Access Compliance Report

Public Rights-of-Way

Intersection ID: 10023486	Main Street: CIRCUMFERENTIAL_RD	Cross Street: N/A	Location: SE
ADA ID: 3DFBCBB8D372	Ramp Type: Directional1	Initial Pass/Fail: Fail	Overall Compliance: No
Codes/Mitigation Info/Possible Solution		Field Measurements/Component Compliance	
Severity Score: 1.25

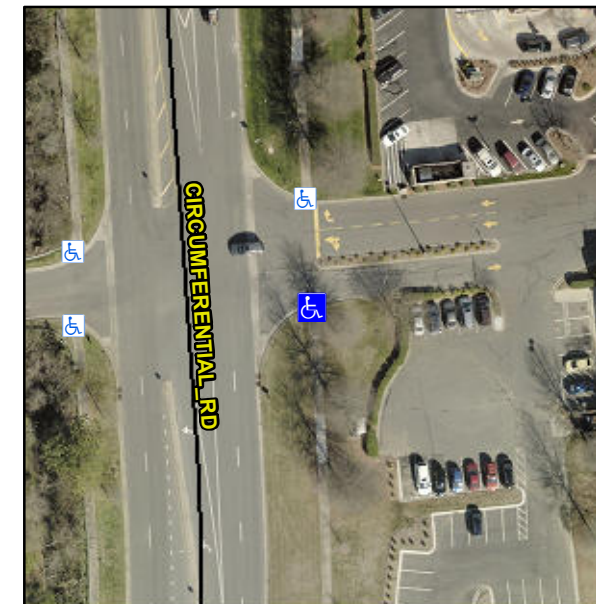
R304.5.3

Compliance	Description	Data	Compliance	Description	Data
N/A	Ramp Length (in)	62.0	N/A	Grade Break?	N/A
Yes	Ramp Width (in)	58.0	N/A	Grade Break Slope (%)	0.0
Yes	Ramp Slope (%)	3.2	N/A	Grade Break XSlope (%)	0.0
No	Ramp XSlope (%)	2.3			
N/A	Flare Type LT	N/A	N/A	Flare Type RT	N/A
N/A	Flare Slope LT (%)	N/A	N/A	Flare Slope RT (%)	0.0
N/A	Flare Traversable LT?	N/A	N/A	Flare Traversable RT?	N/A
N/A	Landing Length (in)	0.0	N/A	DWS Provided?	N/A
N/A	Landing Width (in)	0.0	N/A	DWS Contrast?	N/A
N/A	Landing Slope (%)	0.0	N/A	DWS Length (in)	N/A
N/A	Landing X Slope (%)	0.0	N/A	DWS Full Width?	N/A
N/A	Landing Curb? (Y/N)	N/A	N/A	DWS Offset LT (in)	N/A
N/A	Shared Landing?	N/A	N/A	DWS Offset RT (in)	N/A
N/A	Gutter Ponding?	0.0	N/A	Gutter Slope (%)	N/A
N/A	Gutter Lip Ht (in)	0.0	N/A	Gutter X Slope (%)	N/A
N/A	Painted X Walk1?	No		Road Slope (%)	0.4
	X Walk 1 Direction	To N		Road X Slope (%)	3.6
	X Walk 1 Width (in)	N/A		Clear Space?	N/A

Remove & Replace Entire Ramp.
